Lower Wisconsin River Watershed
Comment Form

Comment pertains to:
DFIRM Panel # 550522 0150 A **Comment #** 1 **Other** _____

FOR COMMENT #6
HOLLOW
KNIGHT
ZONE X
MELLUM
DRY
ROELKE
ROLIKE
ROAD
ONE A
ZONE X
LIMIT OF STUDY
LIMIT OF STUDY
ZONE X
ZONE X
RM64
RM66

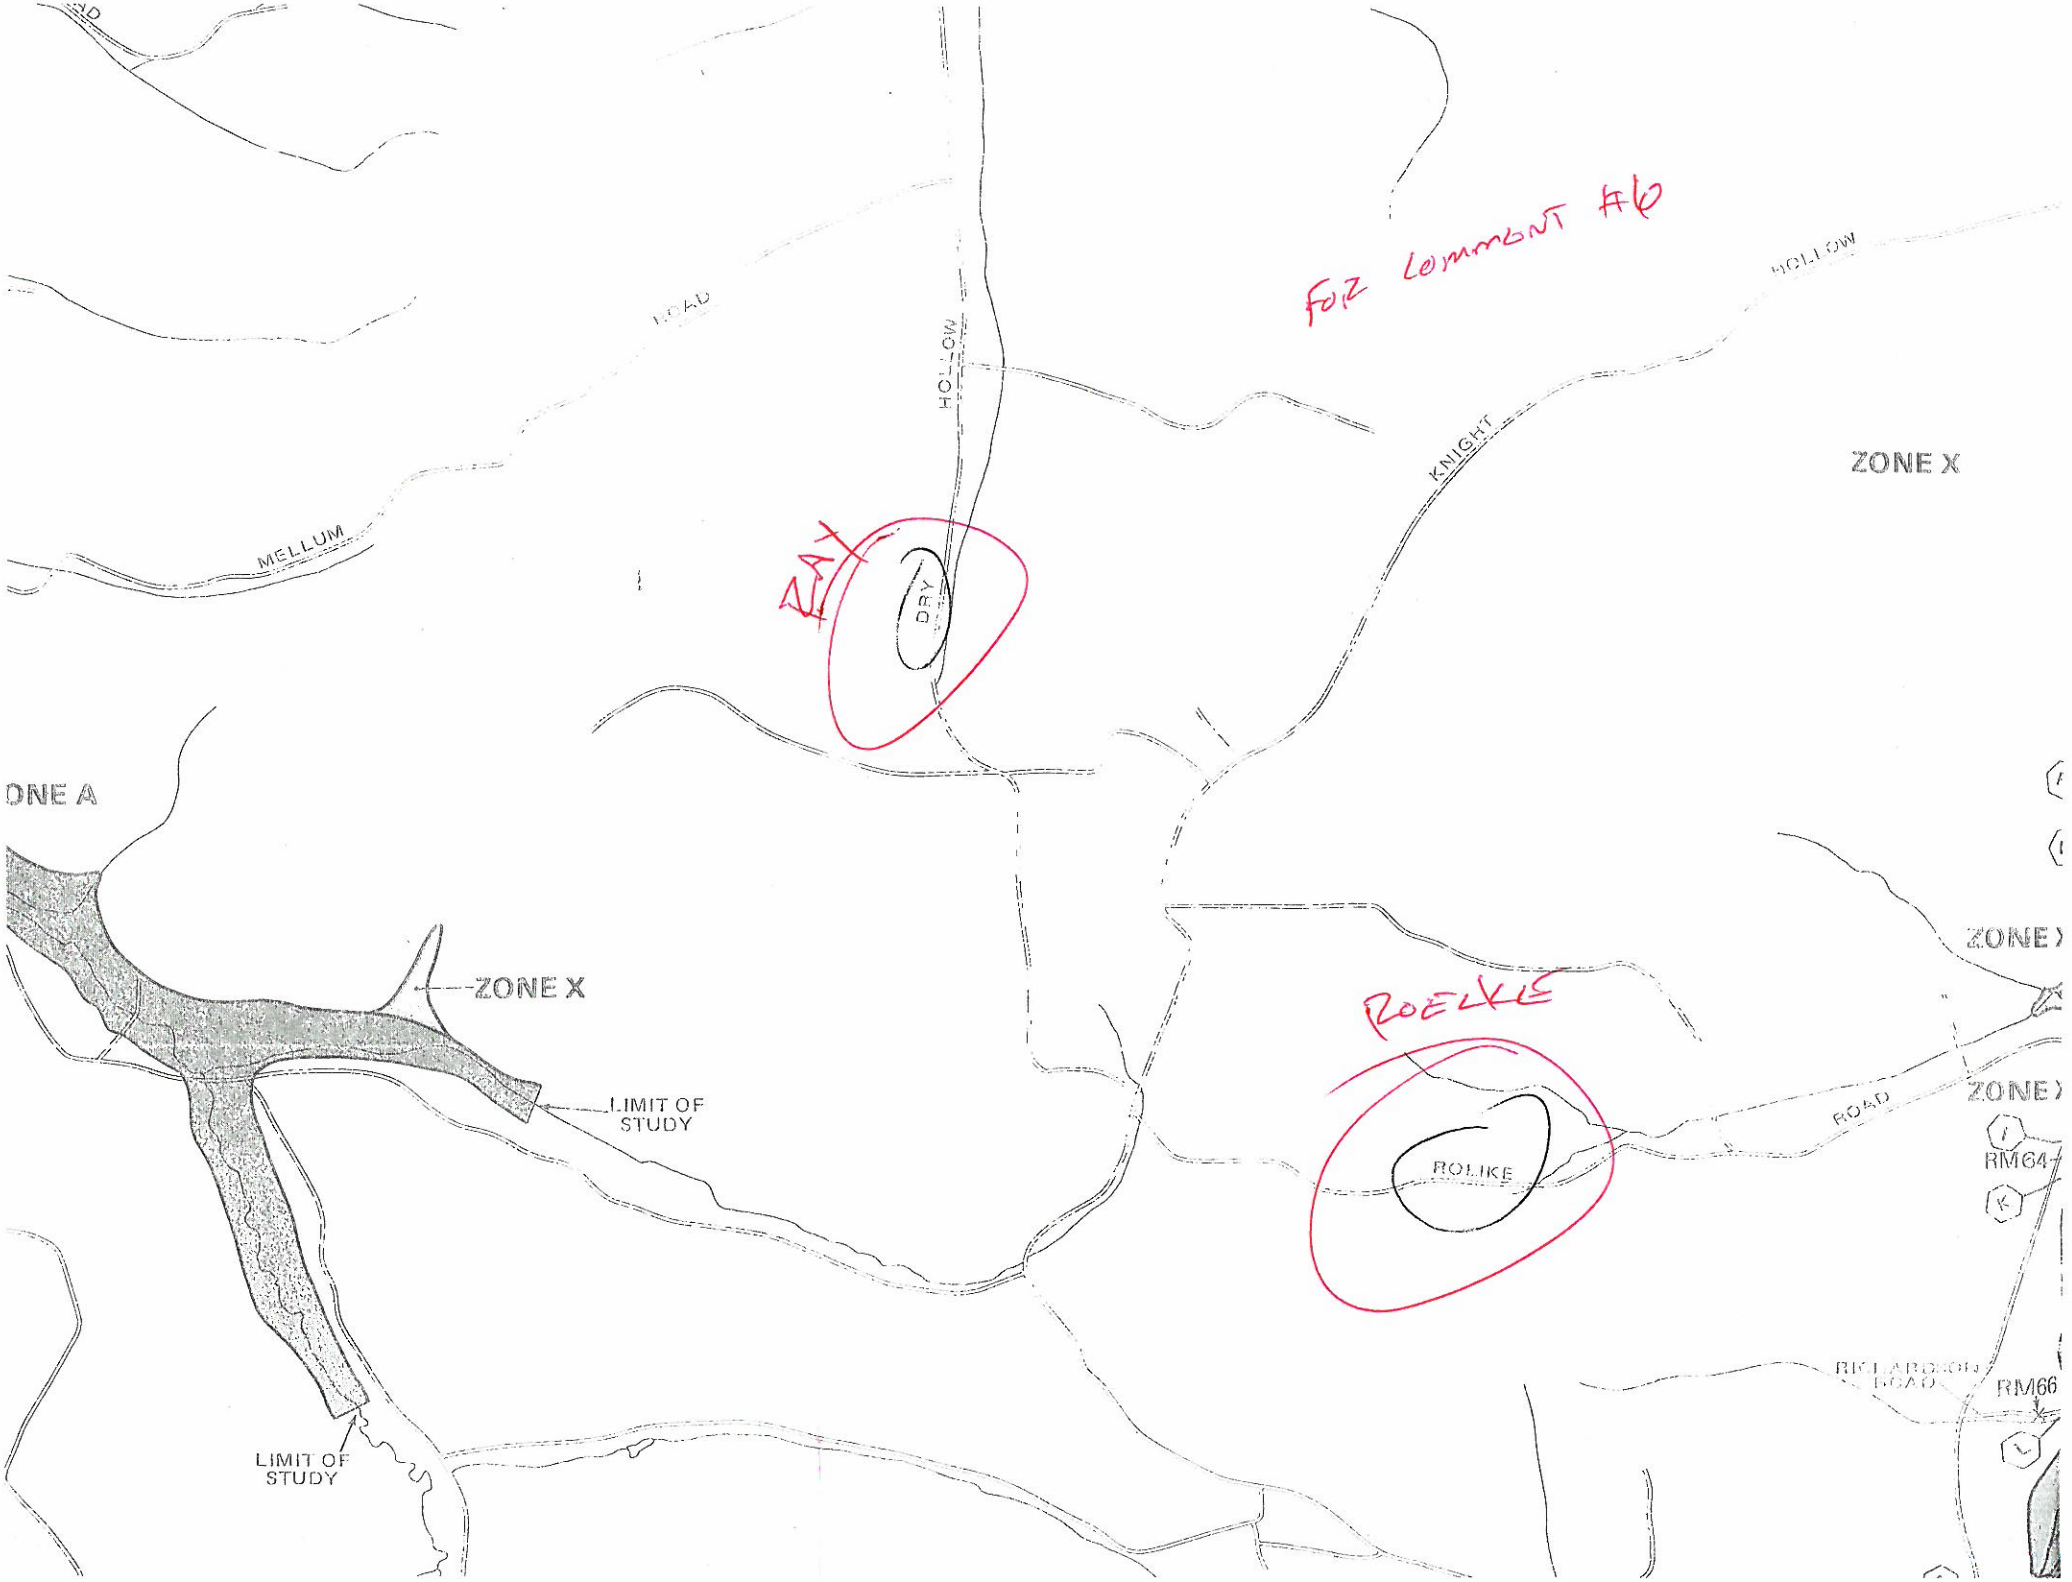
INCORRECT ROAD NAMES: ROECKE NOT ROLIKE

RAY HOLLOW NOT DRY HOLLOW

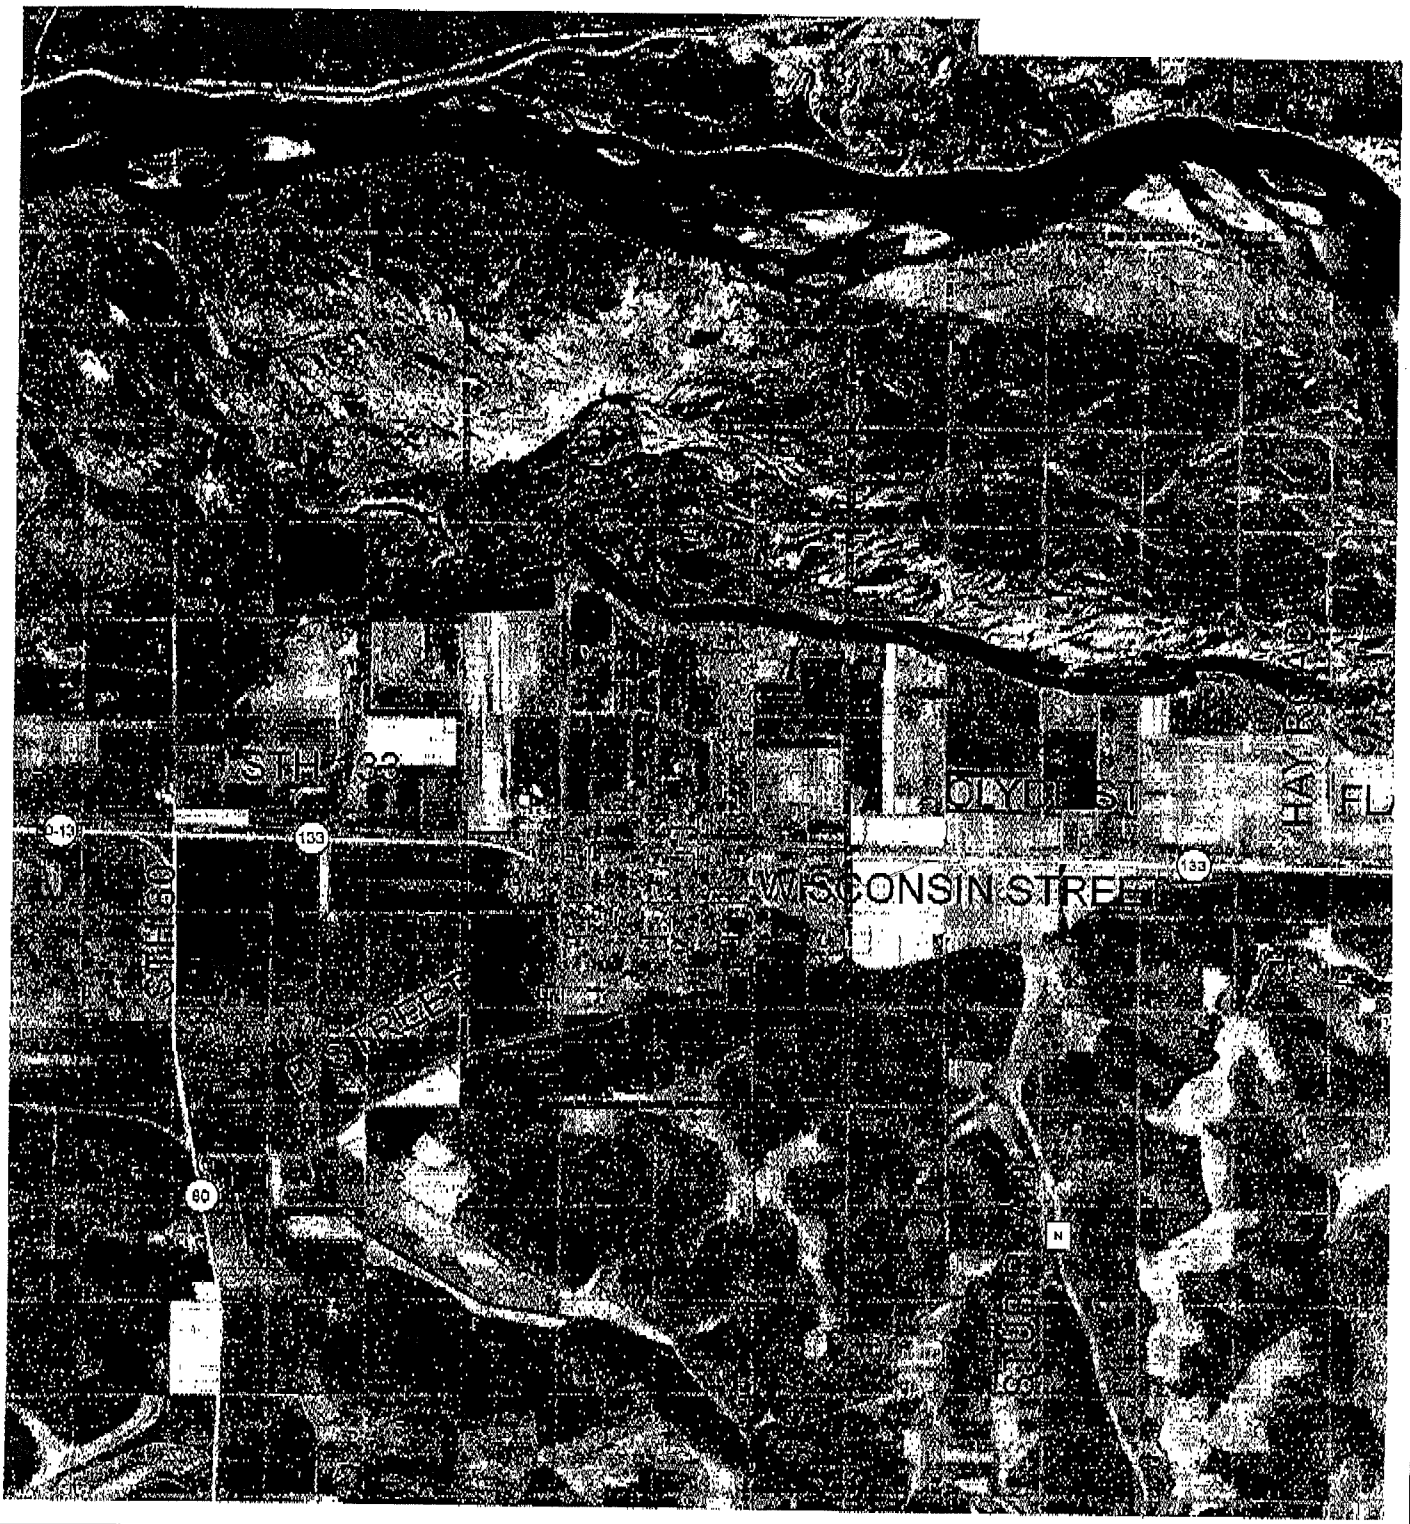
The Avoca Lake is located in the Village of Avoca and is a great asset to the Village. The lake is considered the back waters of the Wisconsin River. The lake does get high when the Wisconsin River gets very high which does cause some flooding. The Village would really like to see improvements made to the lake which would allow much more recreation to the lake. This would also be great for our Village allowing more recreation. The Avoca Lake use to hold many Ski shows and drew
